**RIDE THE DUCKS INTERNATIONAL**  
Fleet Operations & Safety  
2320 West Highway 76  
Branson MO 65616

**Bulletin No.** SB-00-11-14  
**Release Date:** 1/30/14  
**Effective Date:** 3/3/14  
**Supersedes:** N/A  
**Completion Date:** **March 3,2014**  
**Applicable to:** All Ducks  
**Total Pages:** 1

## **SERVICE BULLETIN**

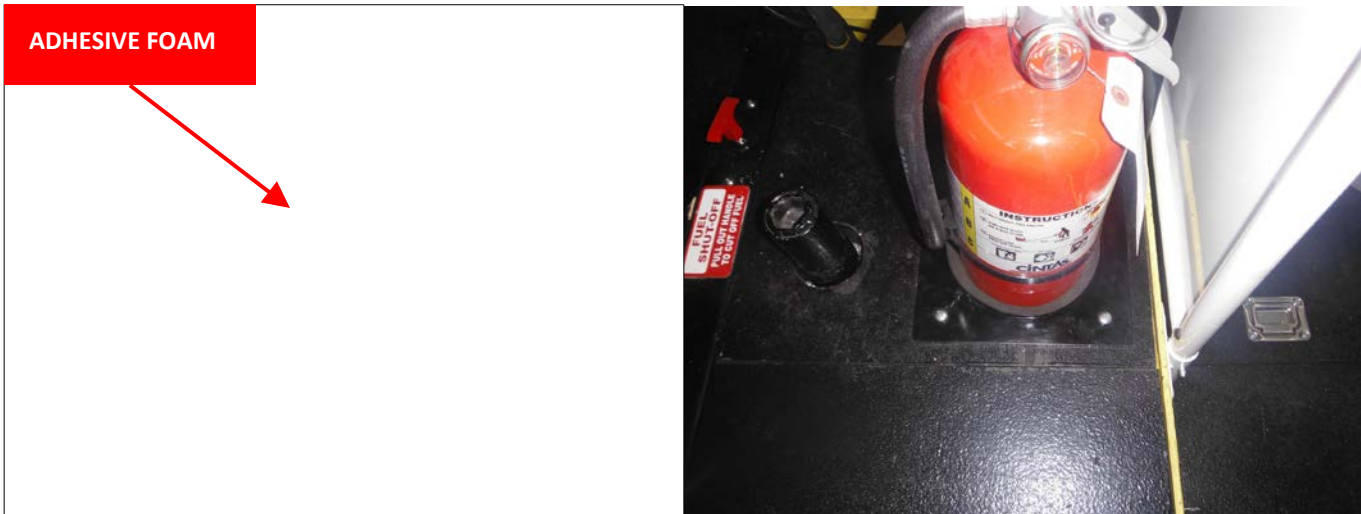
**REASON FOR RELEASE:** To avoid damage to forward portable fire extinguishers due to chaffing. This is in accordance with RTD/USCG approval letter, which granted RTD the allowance to manufacture and use an alternative fire extinguisher holder.

**Directions:** Fire extinguishers that are found undersized for the holder (capable of lateral movement within the holder) are required to be secured from the risk associated with chaffing. This can easily be achieved by installing adhesive foam rubber within the holder, between the fire extinguisher and holder itself.
